# I-270 over the Mississippi River

## Phase I Study - Addendum

***Exhibit C – U.S. Coast Guard Navigation Spans Coord.***

**From:** Brad E. Riechmann  
**Sent:** Tuesday, February 18, 2020 4:42 PM  
**To:** 'Monterroza, Allan O CIV' <Allan.O.Monterroza@uscg.mil>  
**Cc:** Cindy Stafford <Cindy.Stafford@Illinois.gov>; Pfeiffer, Travis <Travis.Pfeiffer@parsons.com>; Owen, Billie J <Billie.Owen@illinois.gov>  
**Subject:** I-270 Bridge Replacement Project - Confirmation of Design Intent

NAVIGATIONAL EXHIBIT  
I-270 OVER MISSISSIPPI RIVER

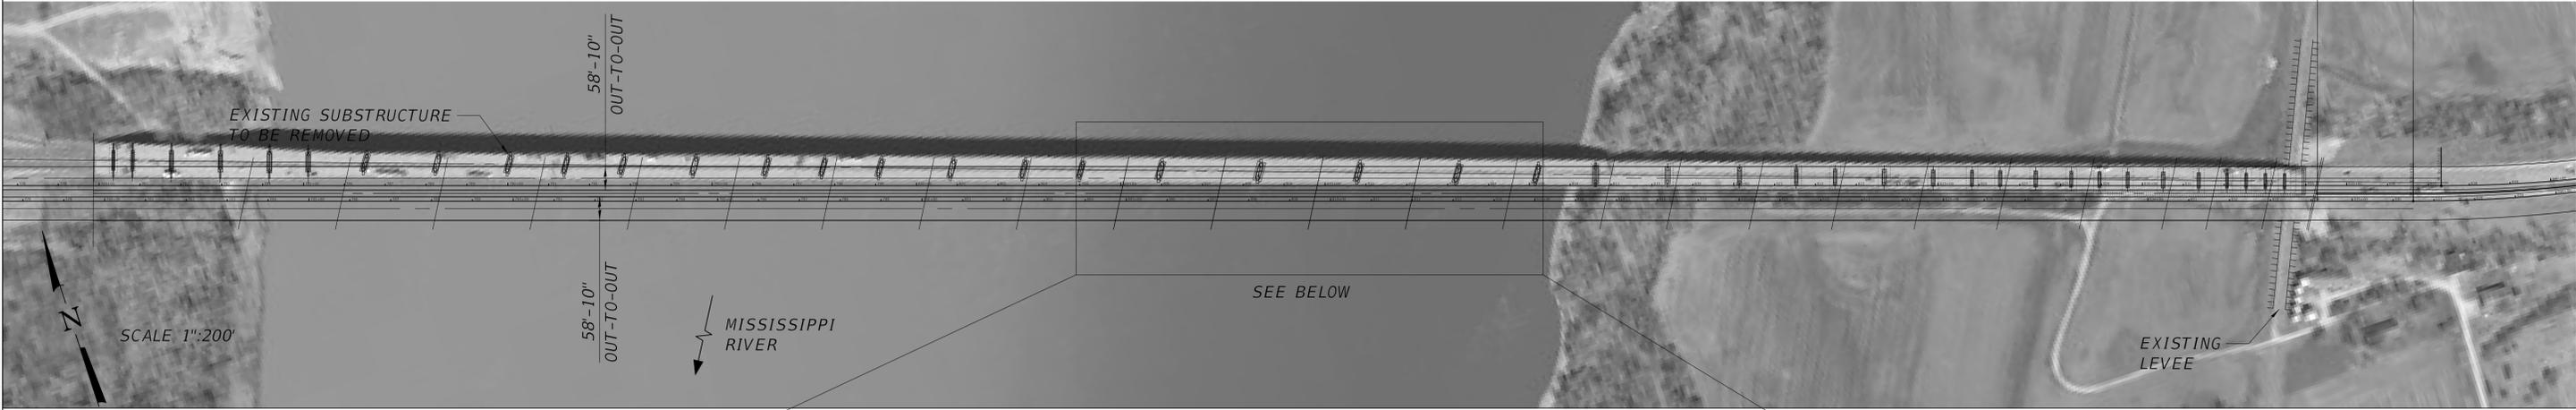
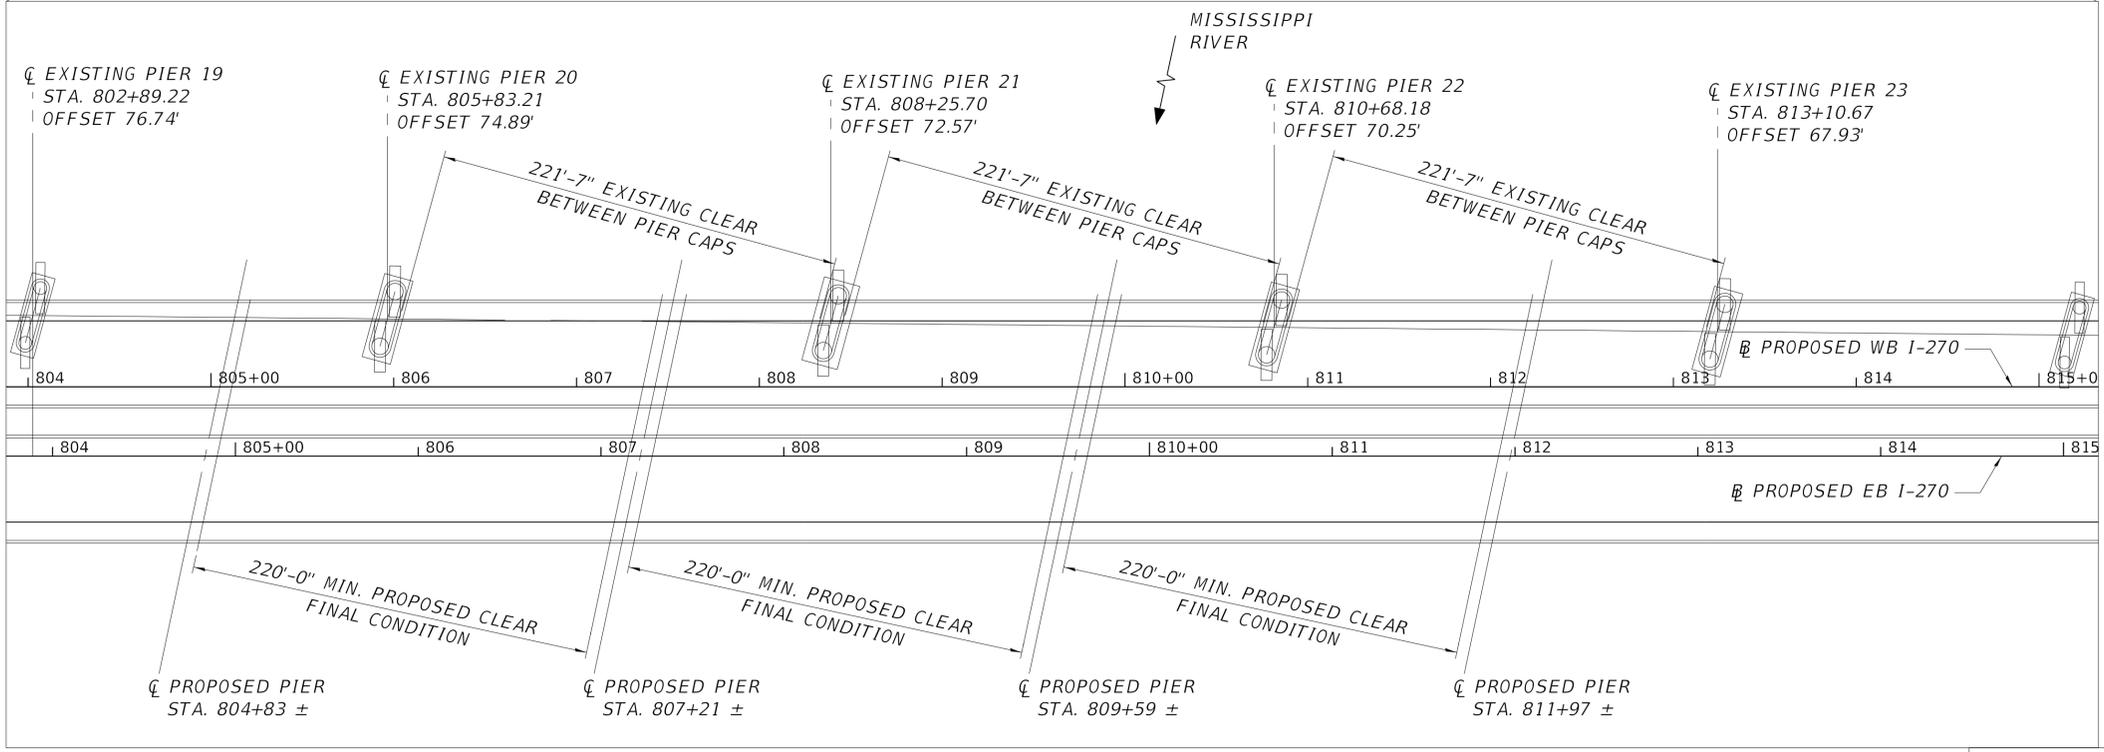
We plan to meet or exceed the existing low steel elevation of 451.63 feet and provide 220' of horizontal clearance for three spans shown in our exhibit previously submitted to your office. No additional clearance criteria are being considered.

This is in reply to Horner & Shifrin, Inc's. email correspondence regarding navigation requirements for replacement of the subject bridge. We have determined for a new bridge at this location it shall meet or exceed the existing horizontal and vertical clearance of the I-270 Highway Bridge located at Mile 190.8. The existing clearances for the I-270 Highway Bridge are: horizontal – 220.0 feet and vertical clearance shall meet or exceed the existing low steel elevation of 451.63 feet. These clearances currently satisfy the reasonable needs of navigation.

NAVIGATIONAL CLEAR DURING CONSTRUCTION NOT CONSIDERED.

PROPOSED NAVIGATIONAL CLEAR  
STATIONING ALONG EB ALIGNMENT
